Z-84  
(2014)

**PETITION NO:** Z-84

**PROPOSED USE:** Attached Residential

**ZONING COMMENTS:**

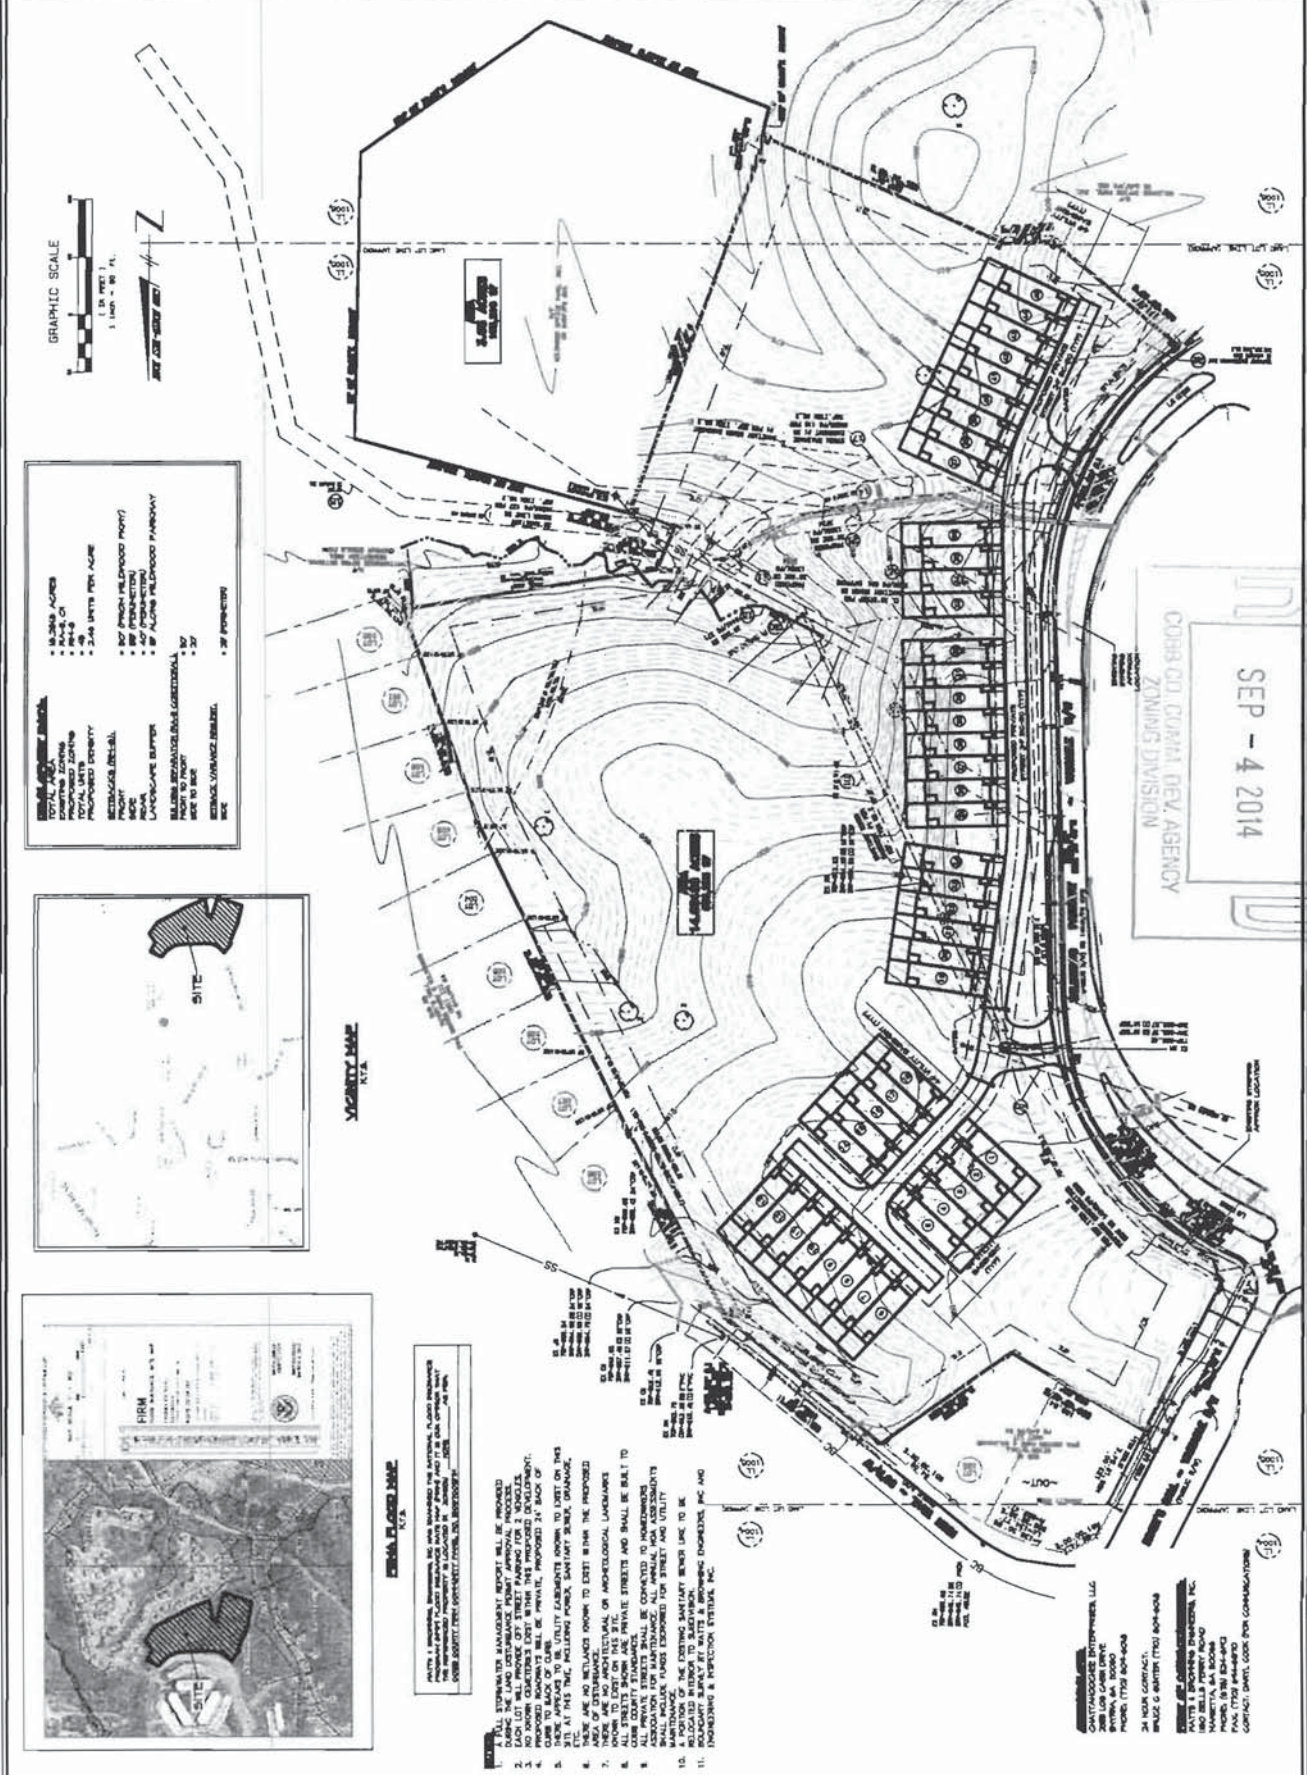
Additional Proposed site plan requires relocation of existing on-site sewer.  
Comments:

- Provide comprehensive hydrology/stormwater controls to include development of out parcels.
- Submit all proposed site improvements to Plan Review.
- Any **spring activity** uncovered must be addressed by a qualified geotechnical engineer (PE).
- Structural fill \_\_\_\_\_ must be placed under the direction of a qualified registered Georgia geotechnical engineer (PE).
- Existing facility.
- Project must comply with the Water Quality requirements of the CWA-NPDES-NPS Permit and County Water Quality Ordinance.
- Water Quality/Quantity contributions of the existing lake/pond on site must be continued as baseline conditions into proposed project.
- Calculate and provide % impervious of project site.
- Revisit design; reduce pavement area to reduce runoff and pollution.

- No Stormwater controls shown \_\_\_\_\_
- Copy of survey is not current – Additional comments may be forthcoming when current site conditions are exposed.
- No site improvements showing on exhibit.

1. This parcel is located between Wildwood Parkway and Rivers Call Subdivision and discharges directly into the National Park Service property to the east. Slopes on this site are steep and approach 35 to 40 percent in some areas. The proposed plan limits the land disturbance to the portion of the site adjacent to Wildwood Parkway. However, due to the close proximity of the project to the Chattahoochee River National Park elevated erosion and sediment control measures are recommended. If possible a temporary mulch berm should be installed at the limit of disturbance as an additional control measure until the site is completely stabilized.
2. There is an existing 42-inch CMP storm drain that conveys offsite runoff through the site. The condition and integrity of this pipe must be verified during plan review. Adequate conveyance of offsite flow through the site must be provided.
